Access Compliance Report

Public Rights-of-Way

Intersection ID: 15085	Main Street: CAMPBELL_DR	Cross Street: N_SHARON_AMITY_RD	Location: SW
ADA ID: 49EC453B7E6A	Ramp Type: Perp	Initial Pass/Fail: Fail	Overall Compliance: No
		Severity Score: 12.5

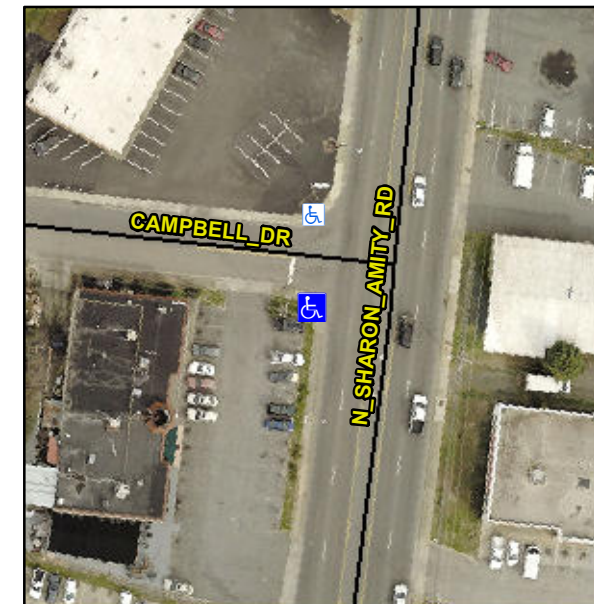
Not Found, R304.2.2

Compliance	Description	Data	Compliance	Description	Data
N/A	Ramp Length (in)	59.5	No	Ramp Slope (%)	9.5
Yes	Ramp Width (in)	48.0	Yes	Ramp XSlope (%)	1.7
N/A	Flare Type LT	N/A	N/A	Flare Type RT	N/A
N/A	Flare Slope LT (%)	N/A	N/A	Flare Slope RT (%)	N/A
N/A	Flare Traversable LT?	N/A	N/A	Flare Traversable RT?	N/A
N/A	Landing Length (in)	N/A	N/A	DWS Provided?	N/A
N/A	Landing Width (in)	N/A	N/A	DWS Contrast?	N/A
N/A	Landing Slope (%)	N/A	N/A	DWS Length (in)	N/A
N/A	Landing X Slope (%)	N/A	N/A	DWS Full Width?	N/A
N/A	Landing Curb? (Y/N)	N/A	N/A	DWS Offset (in)	N/A
N/A	Shared Landing?	N/A			
N/A	Gutter Ponding?	N/A	N/A	Gutter Slope (%)	N/A
N/A	Gutter Lip Ht (in)	N/A	N/A	Gutter X Slope (%)	N/A
N/A	Painted X Walk1?	No	N/A	Painted X Walk2?	N/A
	X Walk 1 Direction	To N		X Walk 2 Direction	N/A
N/A	X Walk 1 Width (in)	N/A	N/A	X Walk 2 Width (in)	N/A
	X Walk 1 Slope (%)	1.6		X Walk 2 Slope (%)	N/A
	X Walk 1 X Slope (%)	4.9		X Walk 2 X Slope (%)	N/A

Remove & Replace Entire Ramp.
